Technical Bulletin

TB No. AA-21032

Revision A

- SUBJECT:** 412EPI Software Upgrade
- PARTS AFFECTED:** **412EPI Bell Helicopter Vibration Monitor (BHVM) System**
P/N 412-360-001
- MODELS AFFECTED:** Bell Textron Inc model 412EP S/N 36373 & Sub with BHTI STC (SR09600RC) installed and BTI 412EP S/N 37002-37999 model helicopters with subject BHVM Kit (412-360-001) installed in accordance with FAA STC SR09373RC.

FIGURE 1 – SYSTEM INFO PAGE REPRESENTATION
(EXAMPLE FOR 412EPI HG - SHOWN)

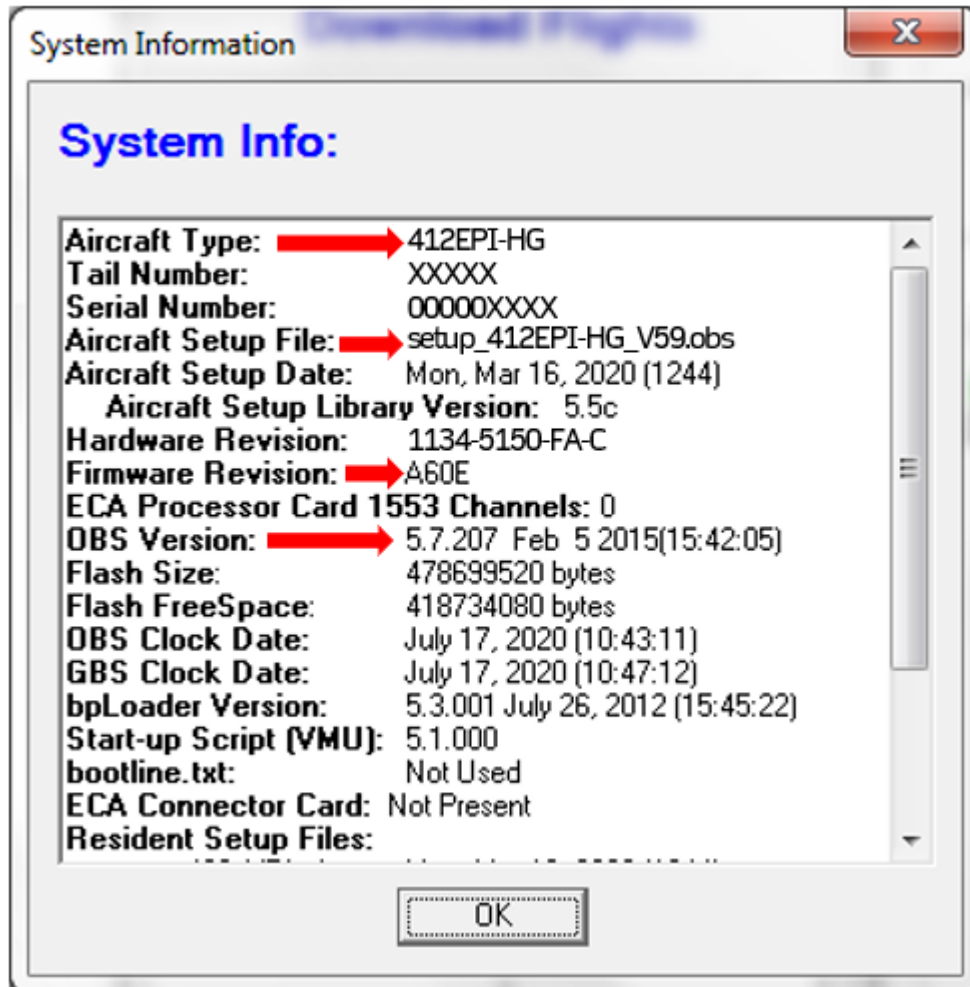
5. The 'System Info' page should represent the following example after successfully loading the 5.7 SP2B V59 or V60 software (see Figure 1).

4. Refer to the following information when verifying the system configuration:

Tail Number: *(Aircraft Serial Number)*

Aircraft Setup File: **SETUP_412EPI-HG_V59.OBS** (for HG)

SETUP_412EPI-LG_V60.OBS (for LG)

OBS Version: **5.7.207**

Firmware Revision: **A60E**

FIGURE 2 - LABEL, P/N 1209-3196-PF

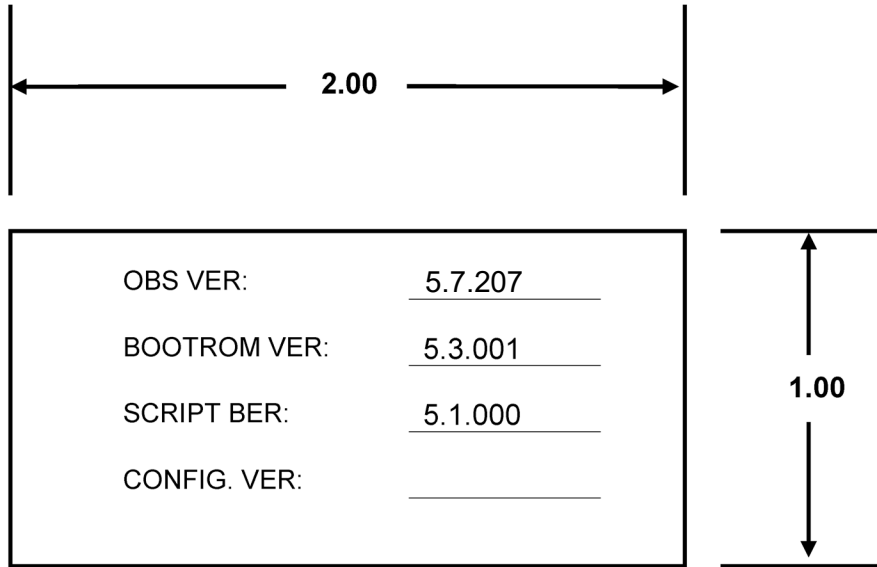
1. Fill in the required data on the 412EPI BHVM Processor Label (1209-3196-PF) as shown in Figure 2. Install Label per Document No. 10123-0002-GP.
2. Verify the information on the existing Label (1209-3198-PF) reflects the current software version. Update the Label, if necessary, as shown in Figure 3.
3. Software update complete.

1. Material Type: Brady Label THT-17-425-3 or equivalent
2. Text Color / Font Size: Black / 9 point
3. Background Color: White
4. Dimensions: Per Figure 2

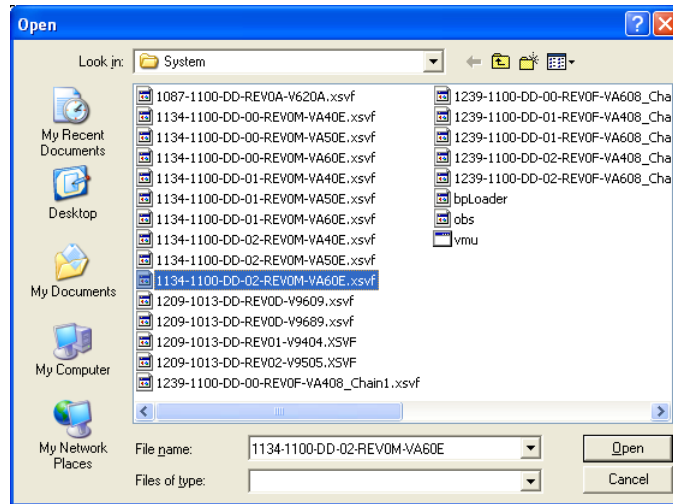
- Revision A of this Technical Bulletin updates the 10123-0002-GP Software Installation Instructions in Appendix A, to revision E. The processor firmware version to select-at-installation is corrected to: "1134-1100-DD-02-REVOM-VA60E.xsvf".

21) Select the 1134-1100-DD-02-REV0M-VA60E.xsvf from 'C:\Program Files (86)\VMEP\Upload\System' and click "Open"
